UNITED STATES PATENT AND TRADEMARK OFFICE

APPLICATION NO.	FILING DATE	FIRST NAMED INVENTOR	ATTORNEY DOCKET NO.	CONFIRMATION NO.
10/725,957	12/02/2003	Jeffrey L. Sands	60246-299	2885
26096	7590	01/18/2005	EXAMINER	
CARLSON, GASKEY & OLDS, P.C. 400 WEST MAPLE ROAD SUITE 350 BIRMINGHAM, MI 48009			HESS, DOUGLAS A	
			ART UNIT	PAPER NUMBER
			3651

DETAILED ACTION

FIG. 3

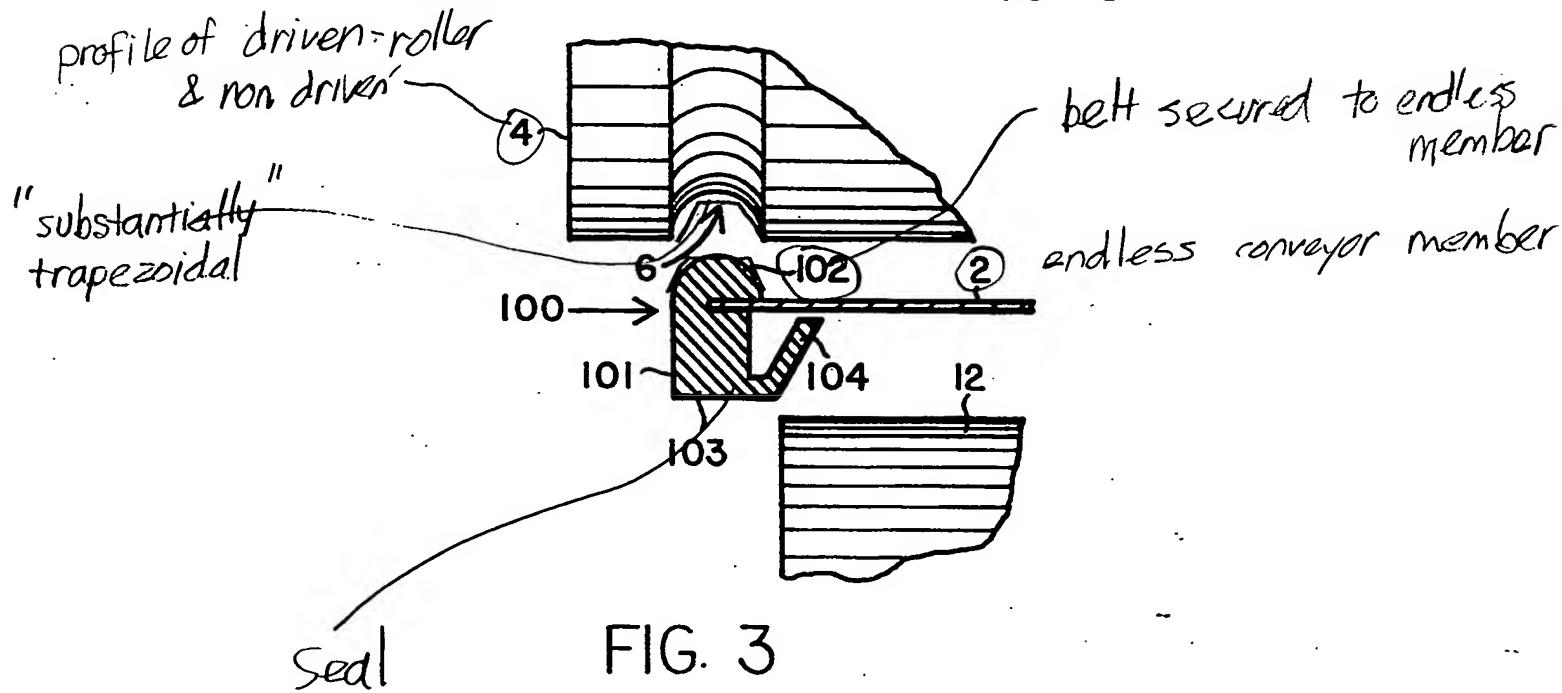
4. Claims 1, 2, and 5-9 are rejected under 35 U.S.C. 102(b) as being anticipated by Foote et al. (US Pat. 5,369,477).

See the attached marked up drawing figure 3 of Foote et al. depicting the claimed features.
